Addendum Number 03

Project: 3916.00 Dorothea Dix Building H Park Lot Design
March 24, 2014

SHEET TITLE:
**ADDENDUM #3
 SITE REMOVALS PLAN**

ADD3-CD101-1

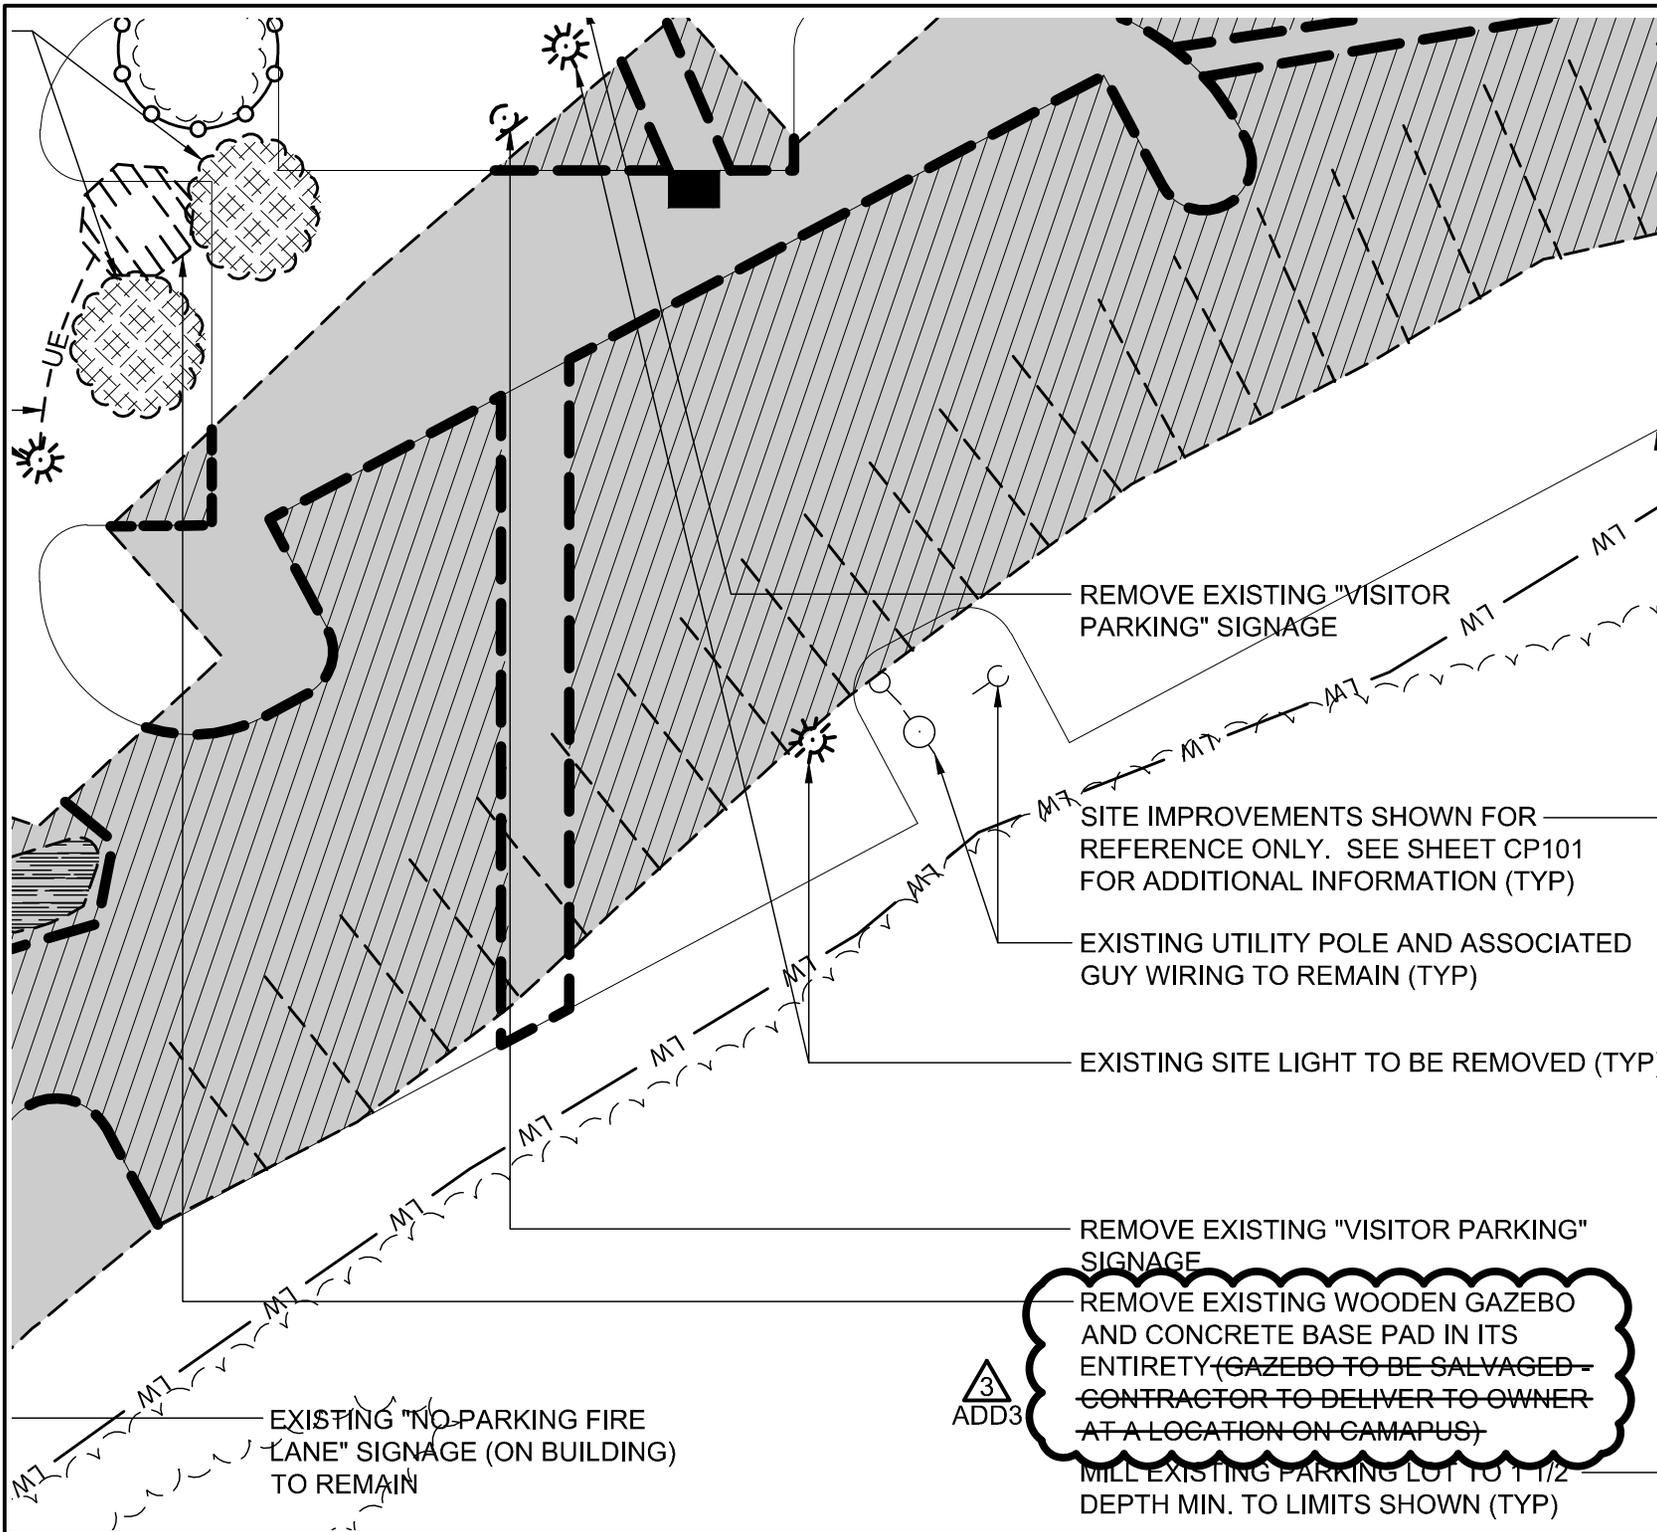
2. Sheet CD101, Site Removals Plan, REVISE portions as indicated on Sketches ADD3-CD101-1 and ADD3-CD101-2.
3. Sheet CP101, Site Layout & Materials Plan, REVISE portions as indicated on Sketch ADD3-CP101.

**REMOVE EXISTING WOODEN GAZEBO
 AND CONCRETE BASE PAD IN ITS
 ENTIRETY (GAZEBO TO BE SALVAGED -
 CONTRACTOR TO DELIVER TO OWNER
 AT A LOCATION ON CAMPUS)**
